Serial: RA-19-0004  
March 7, 2019

CATAWBA NUCLEAR STATION, UNIT NOS. 1 AND 2  
DOCKET NOS. 50-413 AND 50-414  
RENEWED LICENSE NOS. NPF-35 AND NPF-52

MCGUIRE NUCLEAR STATION, UNIT NOS. 1 AND 2  
DOCKET NOS. 50-369 AND 50-370  
RENEWED LICENSE NOS. NPF-9 AND NPF-17

**SUBJECT: RESPONSE TO NRC REQUEST FOR ADDITIONAL INFORMATION (RAI)  
REGARDING LICENSE AMENDMENT REQUEST PROPOSING CHANGES TO  
THE TECHNICAL SPECIFICATIONS 3.8.1 FOR CATAWBA NUCLEAR  
STATION, Units 1 and 2**

**Figure 1 – Catawba Nuclear Station SSE v. GMRS**

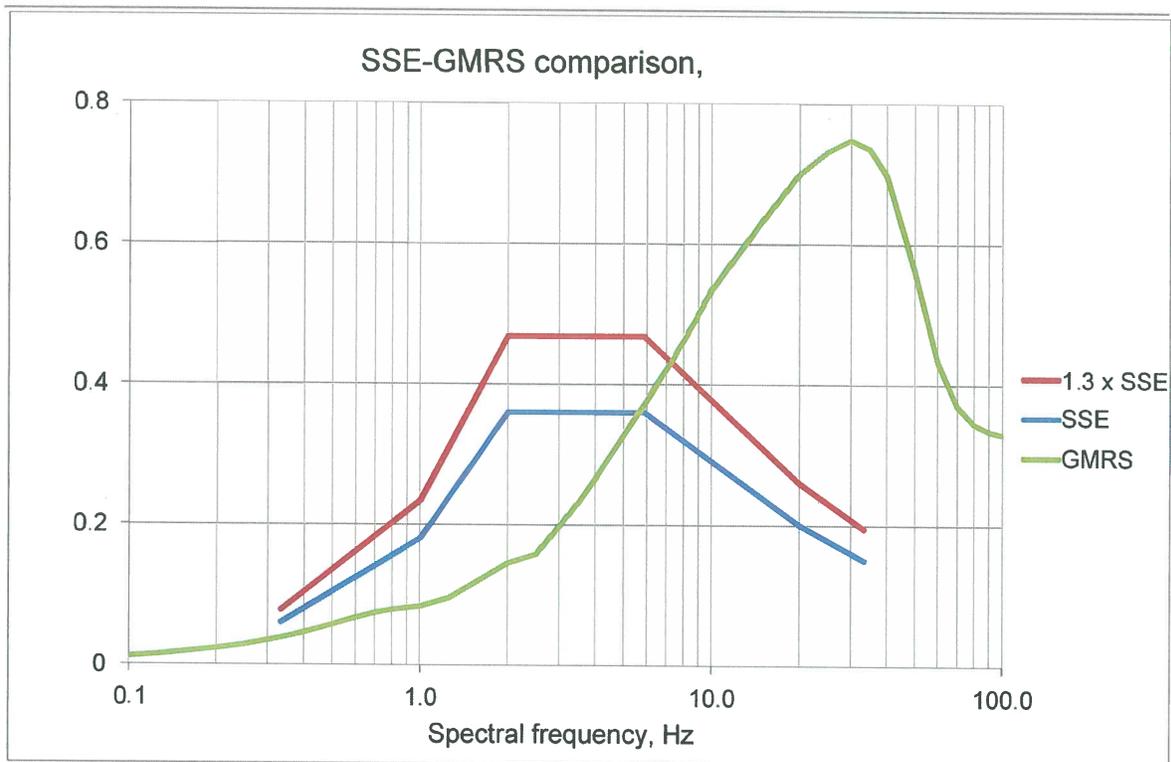
The October 8, 2018 supplement, in response to audit Question 08.a, presents an approach for determining the bounding seismic CDF and LERF increase for the impact of the 14-day EDG outage. As part of the approach, the seismic hazard was divided into six hazard bins and a mean frequency of exceedance was determined for each seismic bin. It appears that these bin frequencies were then combined with conditional core damage probabilities (CCDPs) estimated by using the CCDP resulting from an internal events PRA loss of offsite power (LOOP) initiating event. The response states that seismic events are assumed to result in a LOOP event or to be low enough in magnitude to be subsumed as an internal event. It is not clear to NRC staff that this approach of using internal event CCDPs as a surrogate for seismic event CCDPs produces bounding seismic risk estimates for several reasons. Of primary concern, is that this approach does not account for seismically-induced SSC failures including those that could coincide with the unavailability of an EDG producing potentially significant seismic risk contributions. Also, the response states that human error probabilities (HEPs) are not adjusted to account for seismic scenario specific conditions. NRC staff acknowledges that at a certain magnitude (seismic bin), the fragility of the EDGs may be 100% correlated if they are located on the same elevation and location. In this case, all EDGs either fail or are successful for a given seismic bin, and if all EDGs fail then it is irrelevant whether an EDG is unavailable for test or maintenance. However, for seismic bins in which all EDGs are successful, then the unavailable EDG could coincide with a seismically-induced failure of a non-EDG SSC that produces a significant seismic risk contribution. Considering these observations:

- a) Provide justification (e.g., describe and provide the results of an appropriate sensitivity study) that the seismic risk impacts produced by the analysis provided in

- b) Alternatively, appropriately update the bounding analysis and provide the revised seismic risk estimates with the new PRA results generated in response to RAI-13.

The October 8, 2018 supplement provided a bounding seismic incremental CCDP of  $1.87E-07$  for the 14-day CT. The following analyses provide justification that the value provided can be considered as bounding.

- Figure 1 below shows a comparison of the new GMRS to SSE acceleration response spectra (Ref. 2). From that figure, the design basis SSE exceeds the GMRS below 5.5 Hz, and the GMRS begins to exceed the Catawba SSE above 5.5 Hz. The peak acceleration of the new GMRS is 0.75g at 30 Hz. Ground motions at levels up to 2 times the SSE are expected to produce only a small probability of failure for safety-related SSCs due to conservative design practices. In the high frequency range greater than 10 Hz, structural displacements are small and are considered non-damaging. Thus, the seismic hazard used in the IPEEE evaluation is considered to be conservative in the lower frequency ranges.
